MODEL
TC1966D

REVISION
SUFFIX B

COLOR TELEVISION RECEIVER

SUFFIX	PRODUCT IMPROVEMENT		
A	ORIGINAL		
B	CHANNEL AUTO MEMORY IMPROVEMENT	EARPHONE JACK DELETED	FOR VA

PRINTED CIRCUIT BOARD
MAIN
(SUFFIX B)

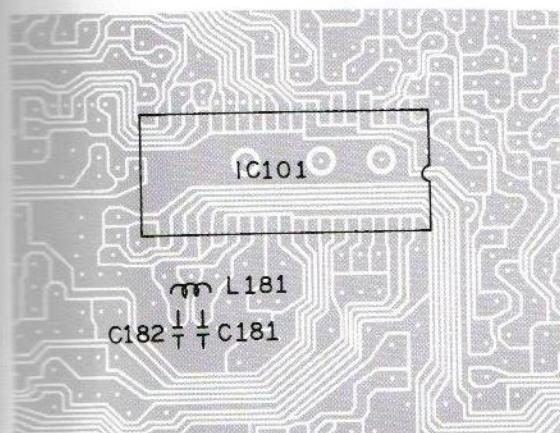
ADD
C181
C182
L181

ADD R481

MECHANICAL EXPLODED VIEW (SUFFIX B)

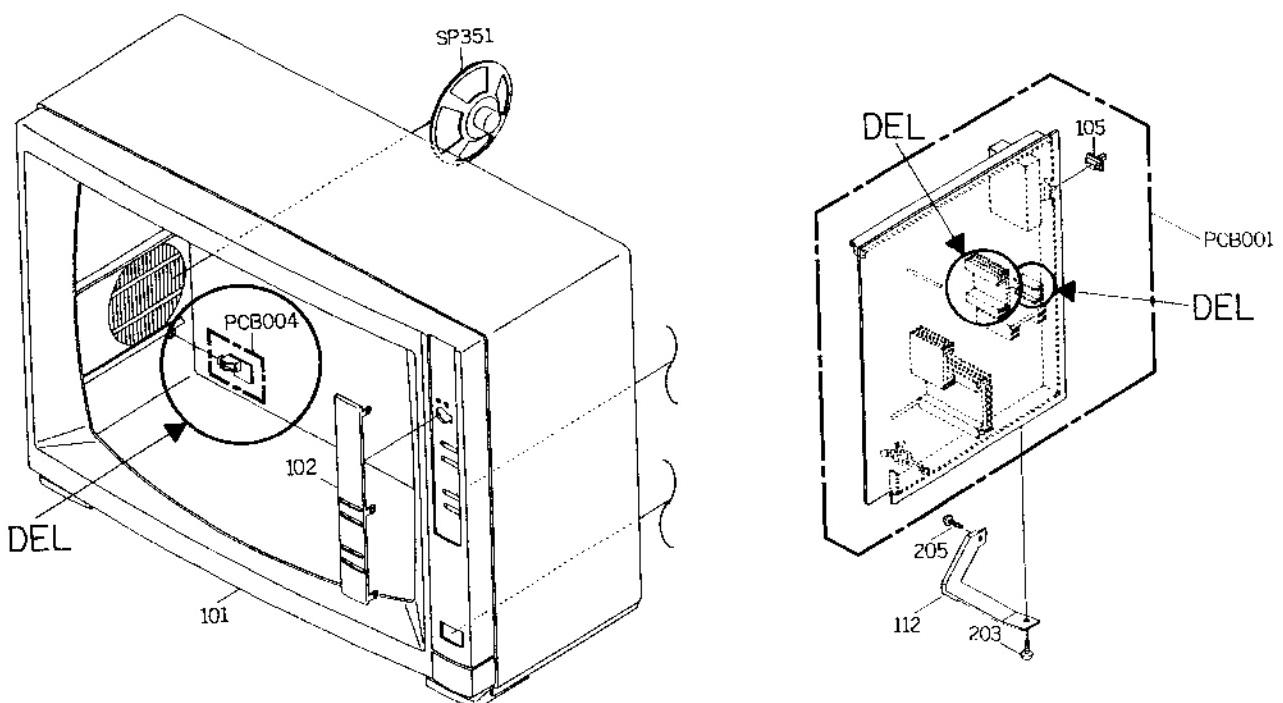
REF. NO	DESCRIPTION	SUFFIX A	SUFFIX B
		PART NO	
101	CABINET, FRONT ASS'Y	A39709A720	A39713A720
	CABINET, FRONT	701APJ0028	701APJ0030
	FILM, INFORMATION	7230003876	7230003875
106	CABINET, BACK	702APA0031	702APA0043
	SHEET, RATING	7222560503	7222560560
	SHEET, UPC-A	_____	7230004393
---	SAFETY INSTRUCTIONS	JTVS00016	DEL
